# **Monitoring Report MY02**

**Stony Fork Restoration Site  
Upper Neuse River Basin - 03020201  
Monitoring Year 02  
DMS Contract 6830**

## MEMORANDUM

Date: February 24, 2021  
To: Lindsay Crocker, DMS Project Manager  
From: Tim Morris, Project Manager  
KCI Associates of North Carolina, PA  
Subject: MY-02 Monitoring Report Comments  
Stony Fork DMS #6830, Contract 006830  
Neuse River Basin CU 030202018  
Johnston County, North Carolina

**CURRENT CONDITIONS PLANVIEW**  
**STONY FORK RESTORATION SITE**  
**JOHNSTON COUNTY, NC**

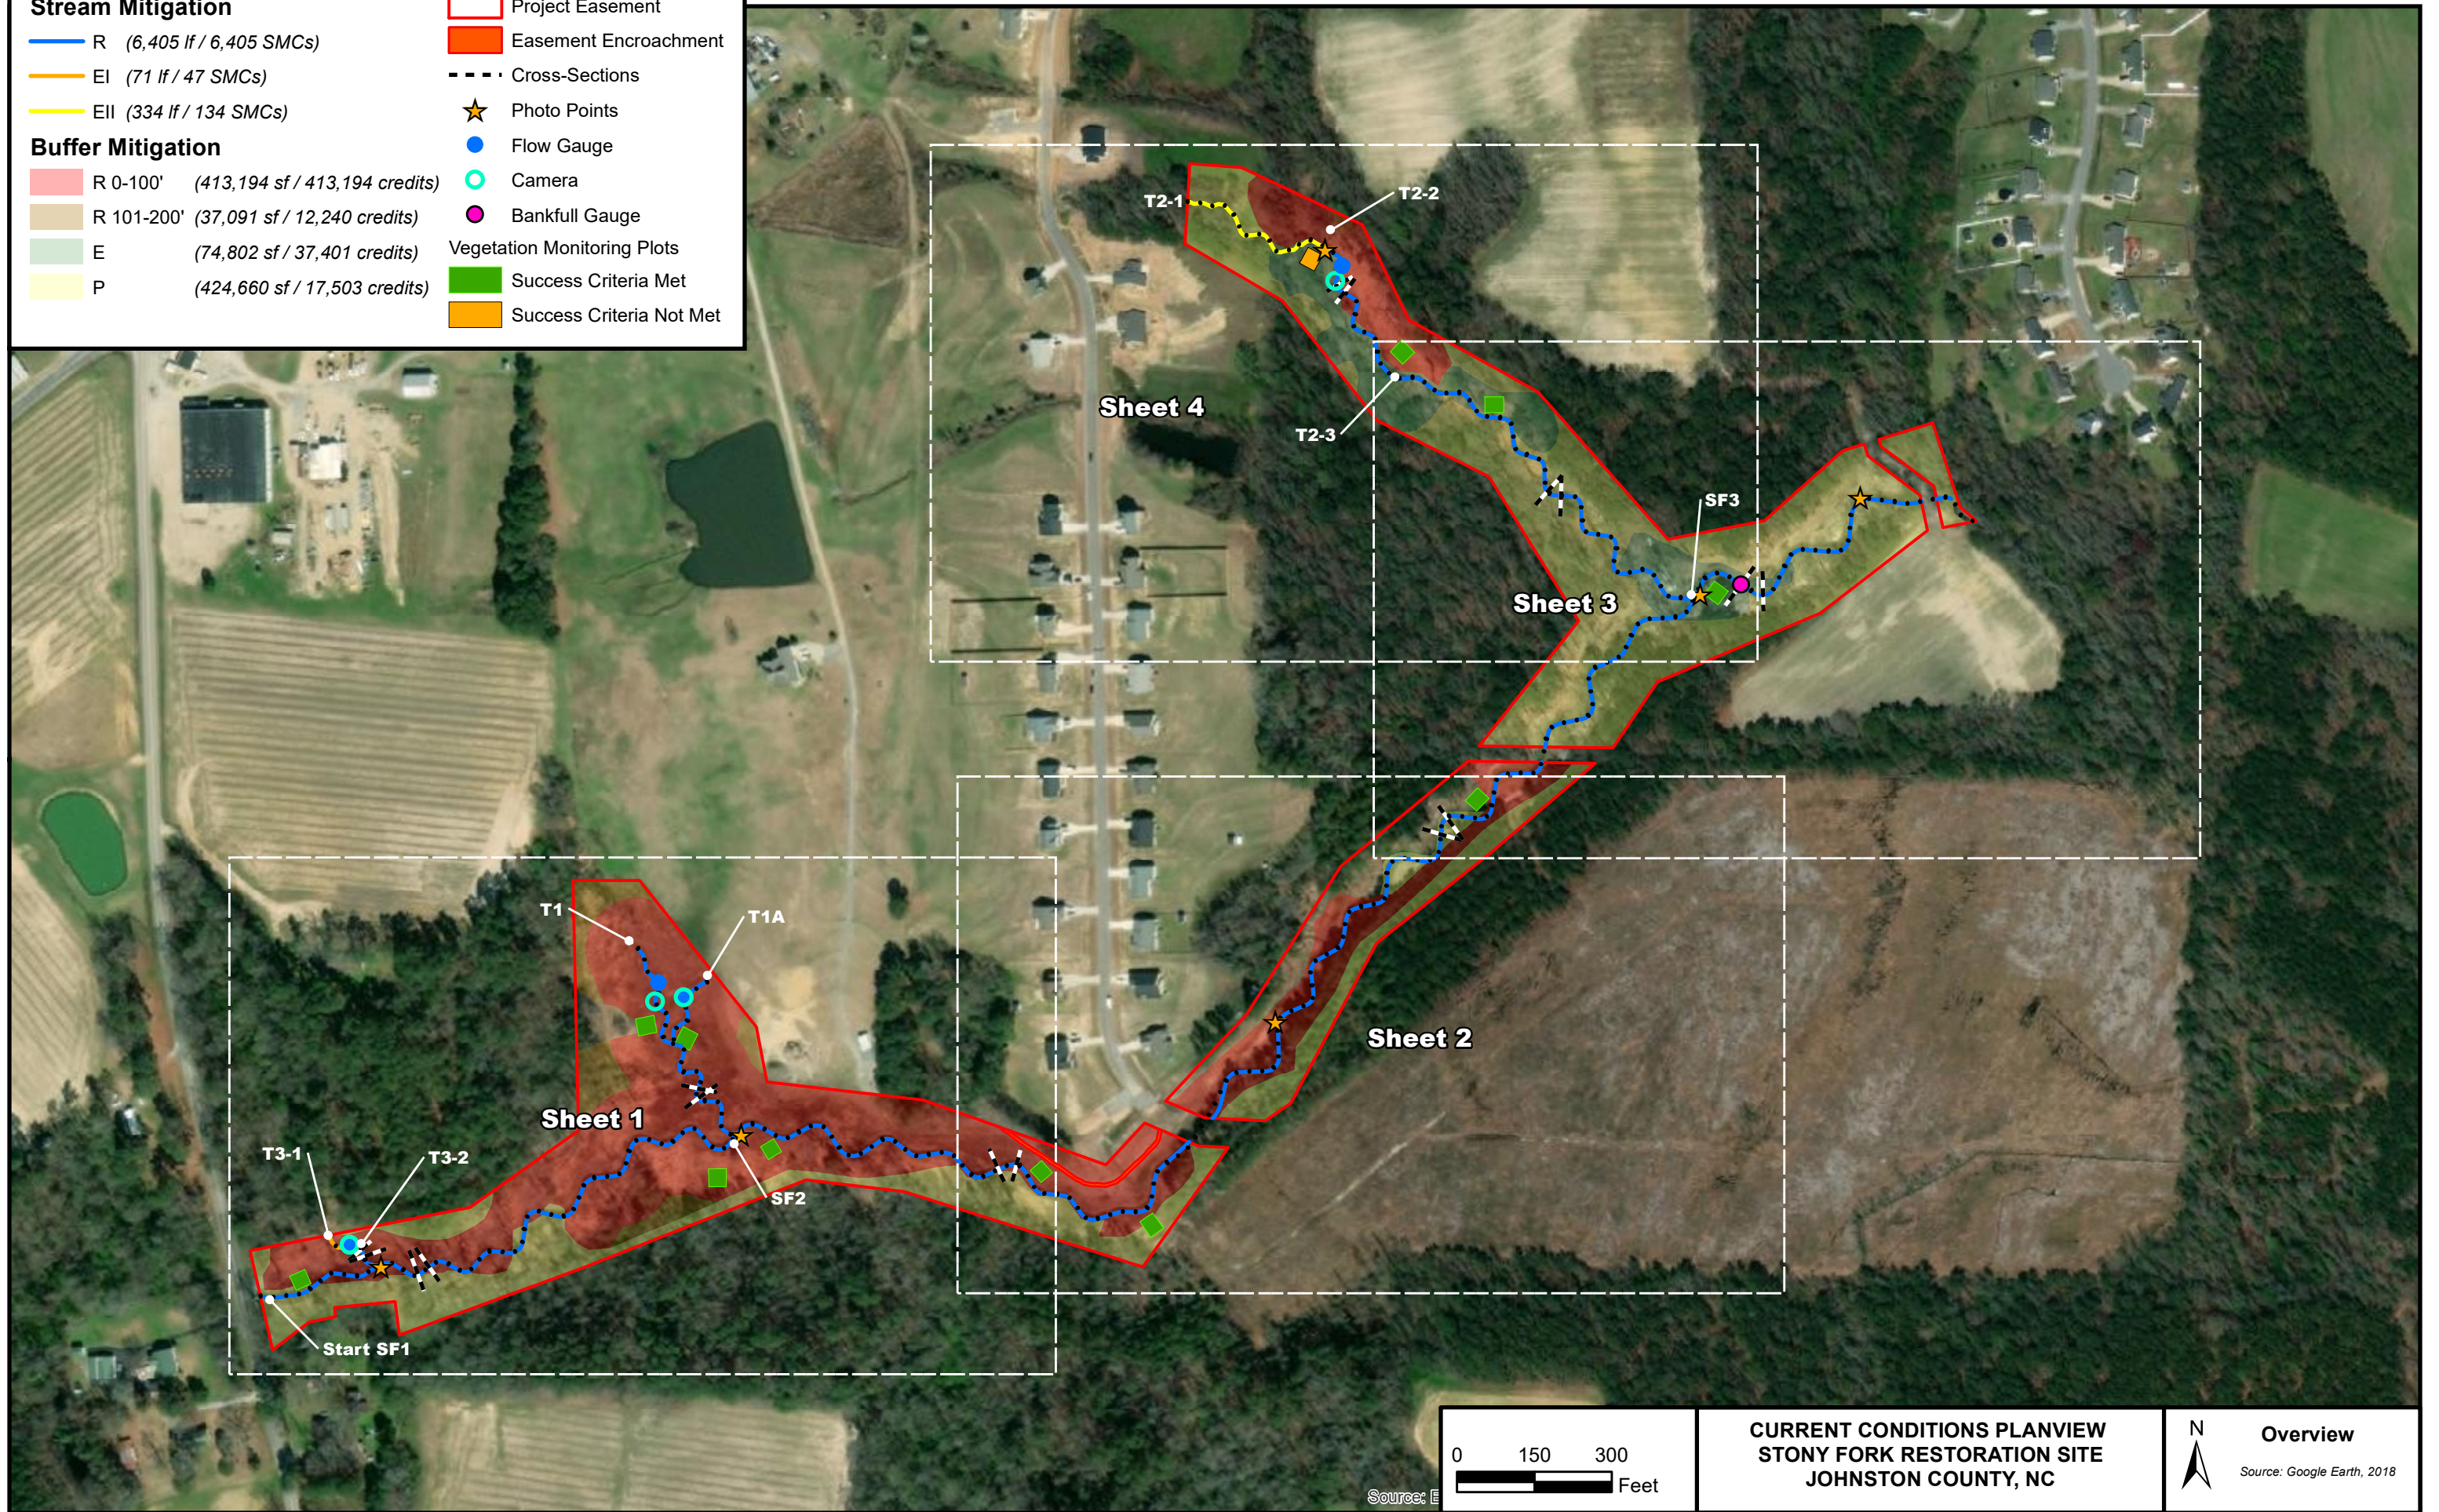
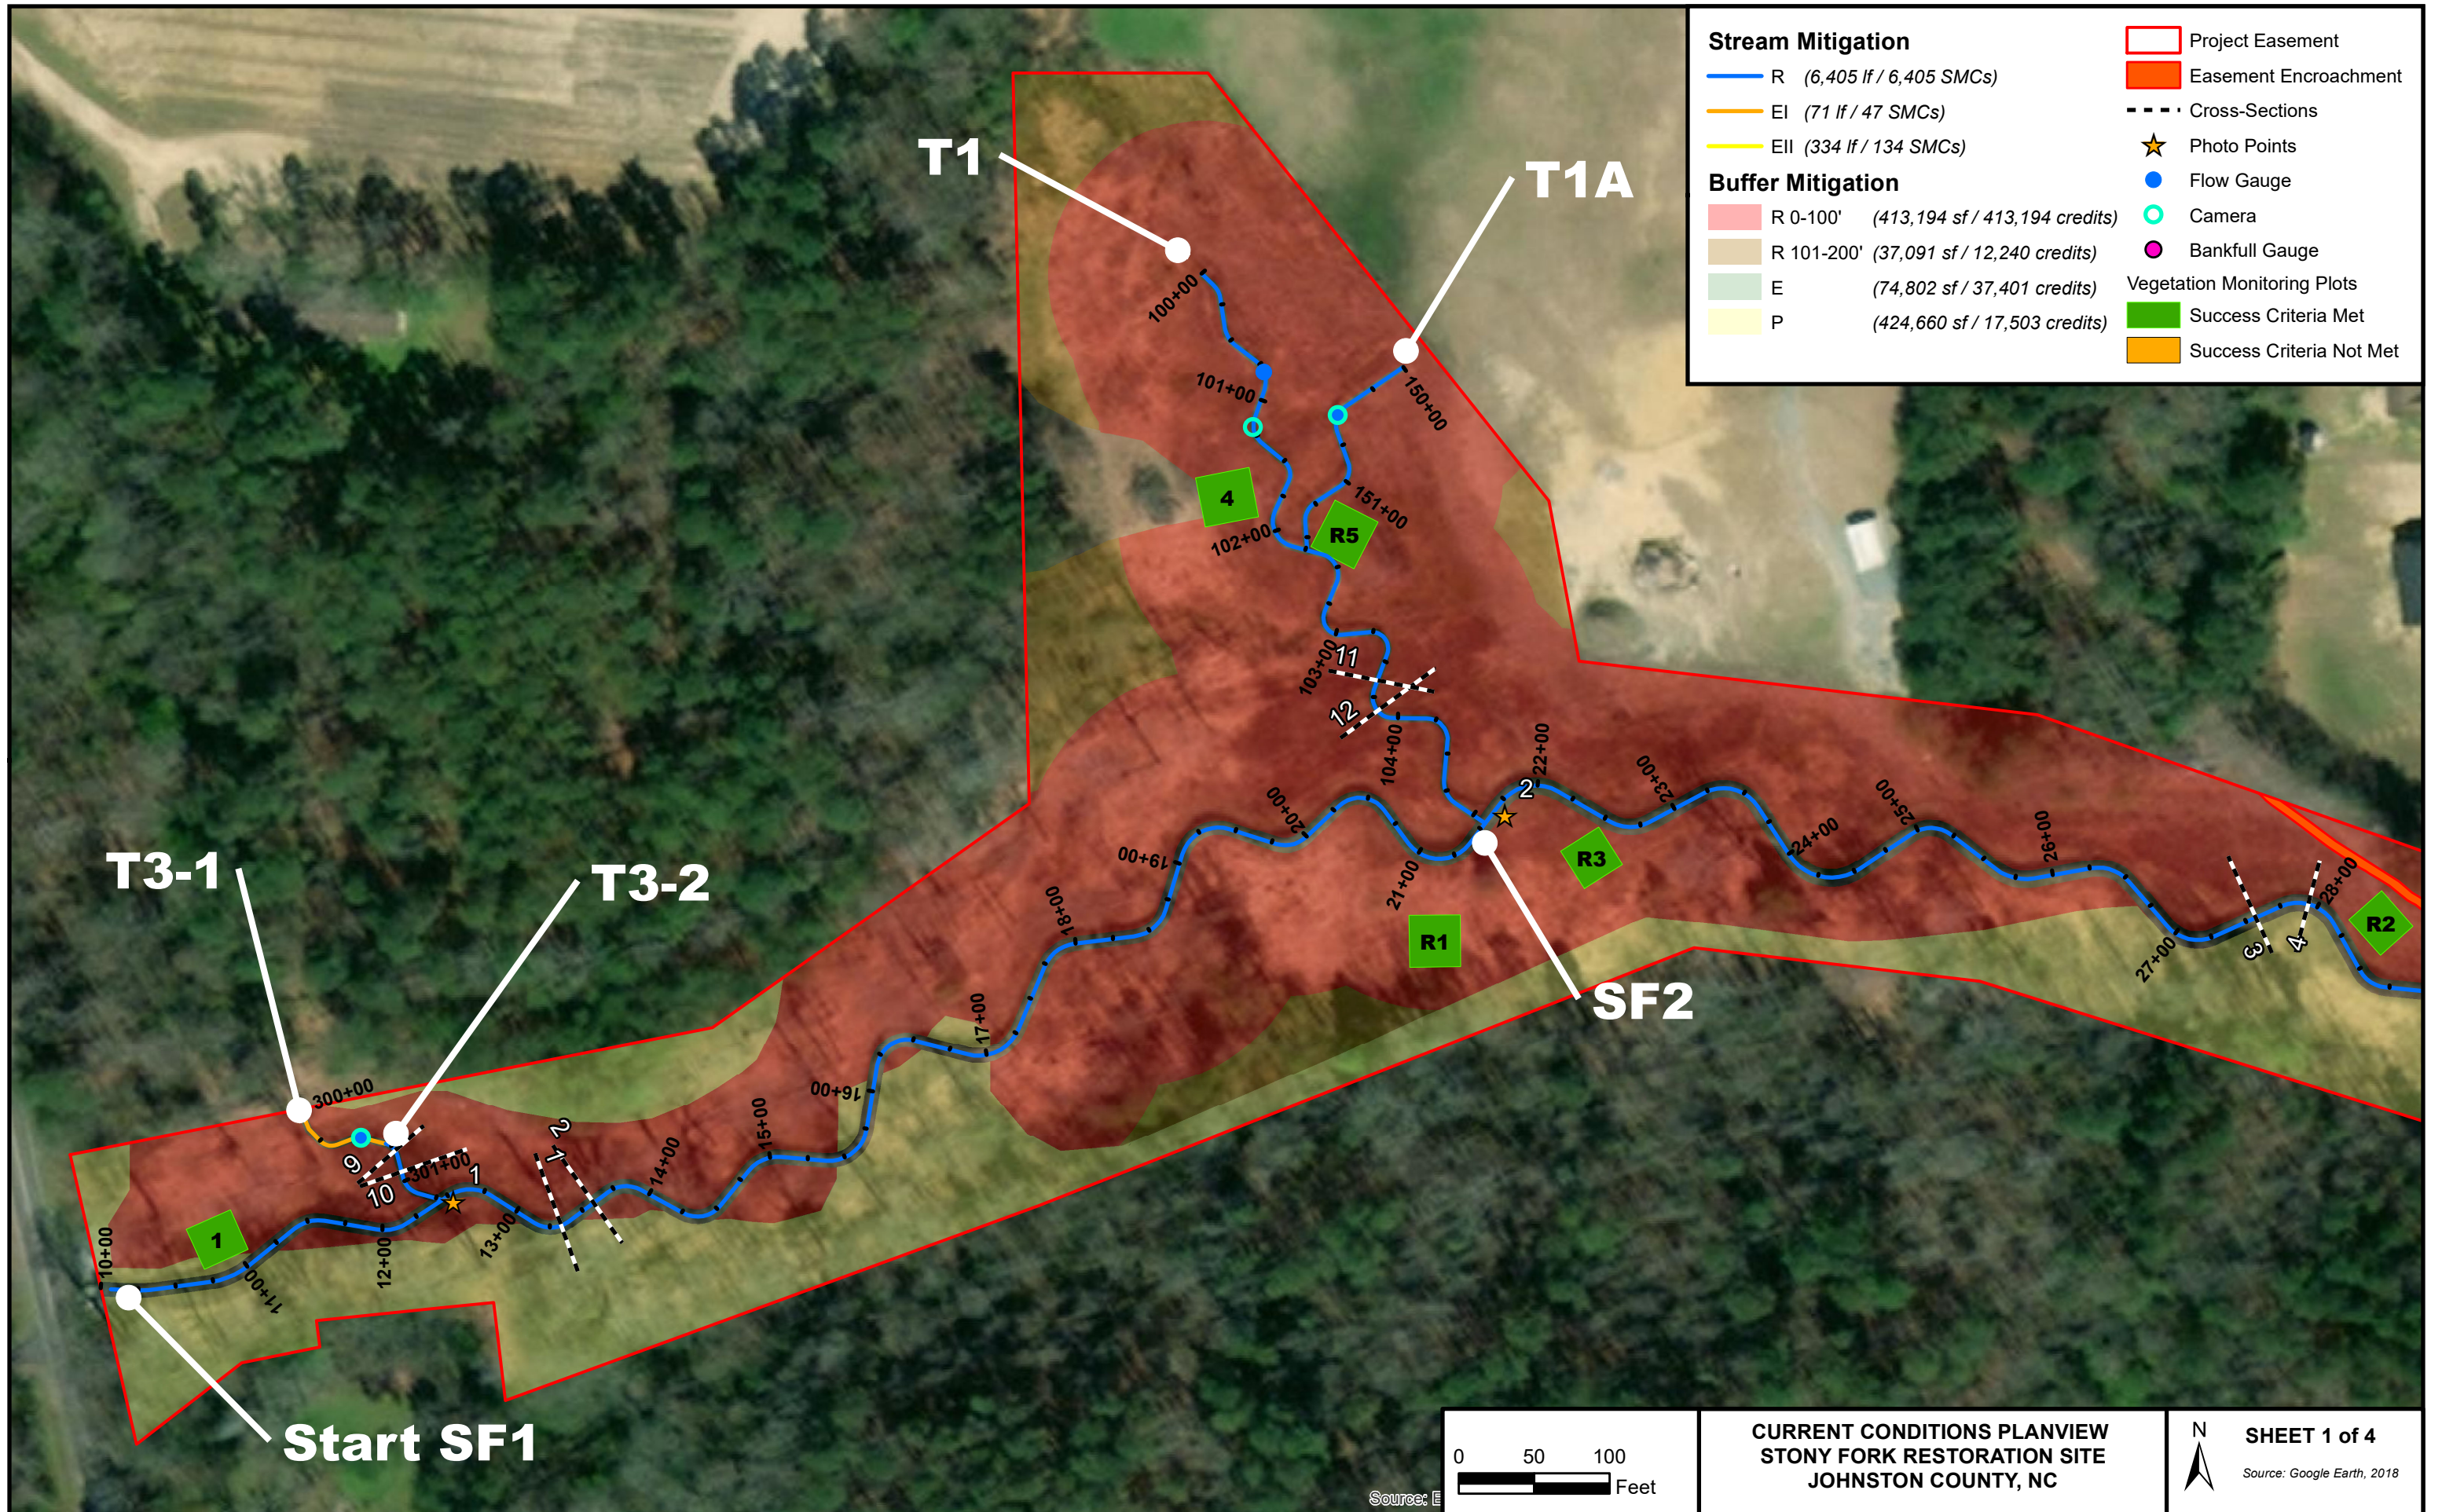
2. Please also document the extent of the encroachment on the CCPV map and measure the area to be reported on the visual assessment table 6 (#5 Easement Encroachment Areas).  
*KCI Response: The extent of the ATV encroachment was surveyed with a handheld GPS on February 9, 2021 and the CCPV and visual assessment table have been updated to show the encroachment.*
